Aspire

2<sup>nd</sup> sufficiency Review

Parks and Recreation

3.12.24

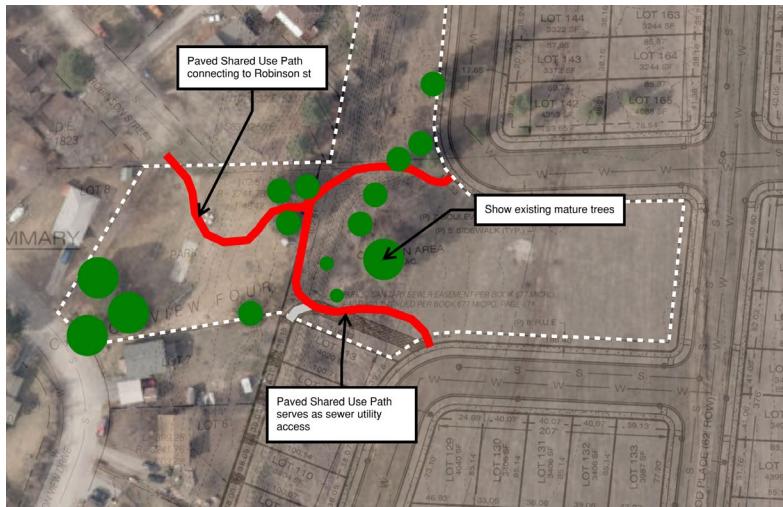
The conceptual boulevard landscaping plans submitted require changes to tree spacing, species selection and distribution, and must show utility offsets and intersection site triangles.

Class 1 trees are not allowed in boulevards unless there are specific overhead utility conflicts. All boulevard trees should be class 2 (or larger if boulevard space permits) selected from the approved street tree list.

Class 1 trees adjacent to pedestrian crossings in particular are not acceptable, due to their smaller size and lower branching habit they obstruct visibility between oncoming vehicles and pedestrians. Class 2 & 3 trees can be pruned in a way that the canopy is higher, keeping site lines open and creating a safer crossing.

No one species of tree can comprise more than 30% of any phase of the subdivision, the plans need to be adjusted to meet this requirement.

The landscape plan needs to be updated with the current version of the Preliminary Plat

For clarity of review the boulevard landscaping plan should be separate from the park landscape plans.

Boulevard landscaping plans need to show offsets from utilities, site triangles, light poles, driveways. It appears that there are several locations that trees could fit where none are shown, but without the offsets shown it is difficult to tell. Utility offsets can be found in the Public Works Standards and Specifications Manual, and Parks and Recreation Design Manual.

**Proposed Condition of approval:** The subdivider shall provide plans for and installation of boulevard landscaping along all public roadways, subject to review and approval by Parks and Recreation. Street trees shall be planted based on requirements found in the Parks and Recreation Design Manual; including species, spacing and distribution.
